Our Ref: QCG-10236

In accordance with the requirements of the Nuclear Regulatory Commission Title 10, Chapter 1, Code of Federal Regulations, Part 21, Cooper-Bessemer Reciprocating Products Division, a division of Cooper Cameron Corporation, hereby notifies the Commission of a potential design defect of the KSV emergency diesel generator (EDG) system.

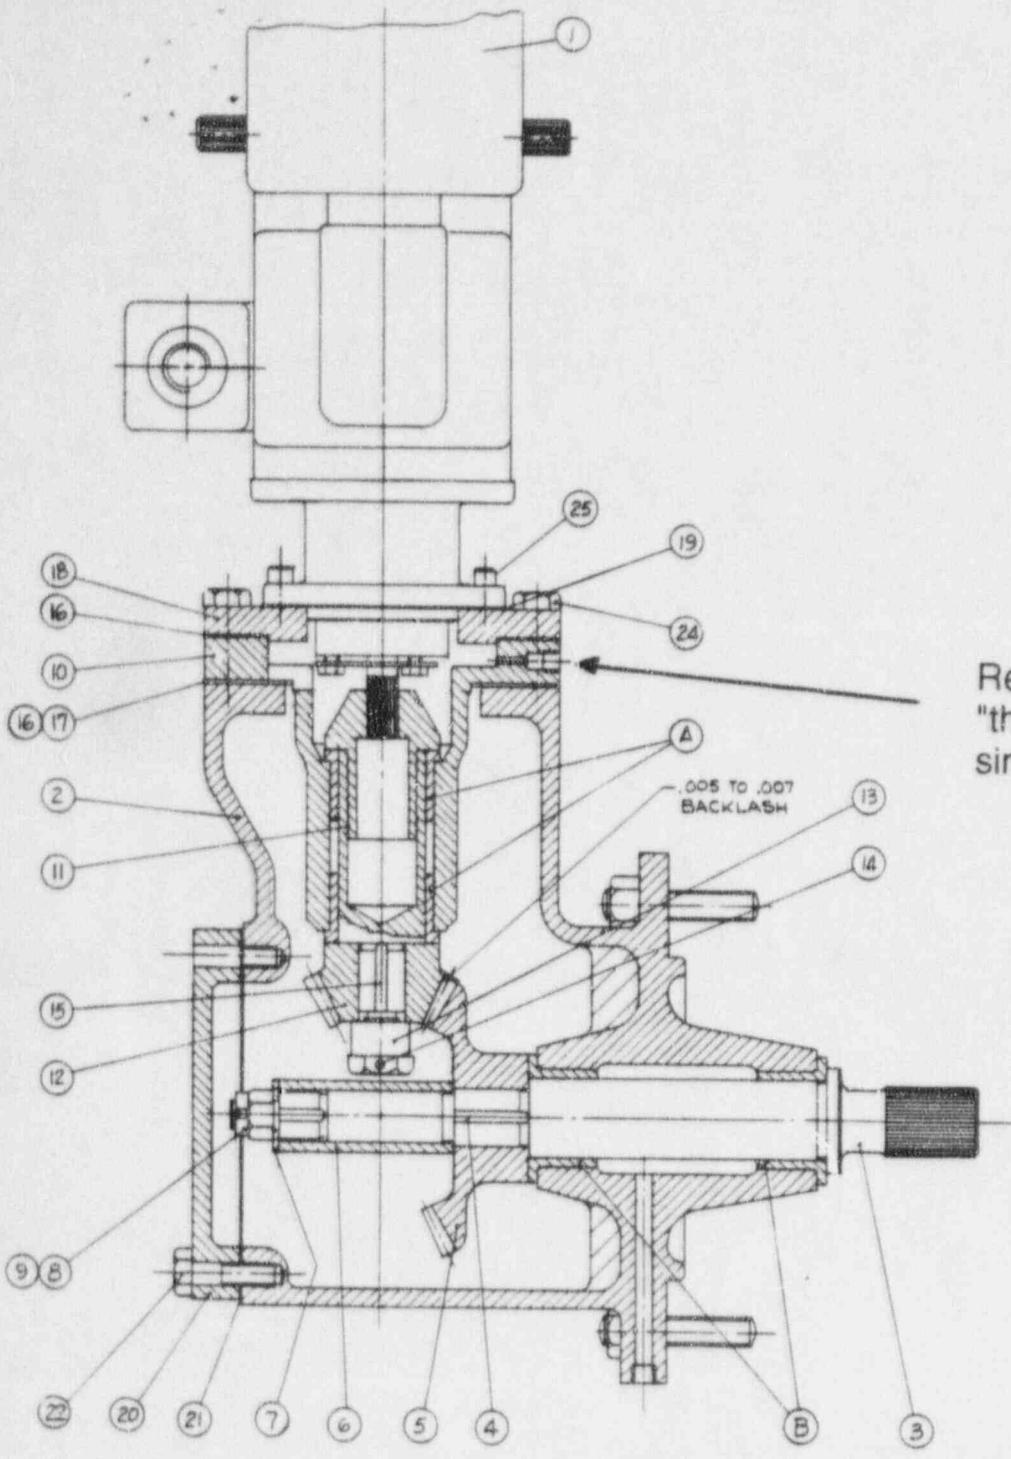
On November 6, 1995, Braidwood Station reported that during maintenance activities excessive wear and rust was noted in the upper portion of the governor drive assembly (Assembly No. KSV-17-6). On November 7, 1995, Braidwood reported that the oil inlet hole in the top flange of the bearing retainer did not appear to extend through to the inside of the flange. The report indicated this was due to a sleeve repair of the bore blocking the oil hole.

Lack of oil in this area could result in failure of this assembly resulting in EDG inoperability. Due to the potential of this defect and the ease of verification, it is recommended that all utilities verify an open oil passage in this assembly (see attachment).

Remove oil line and verify "through" hole using wire or similar object.
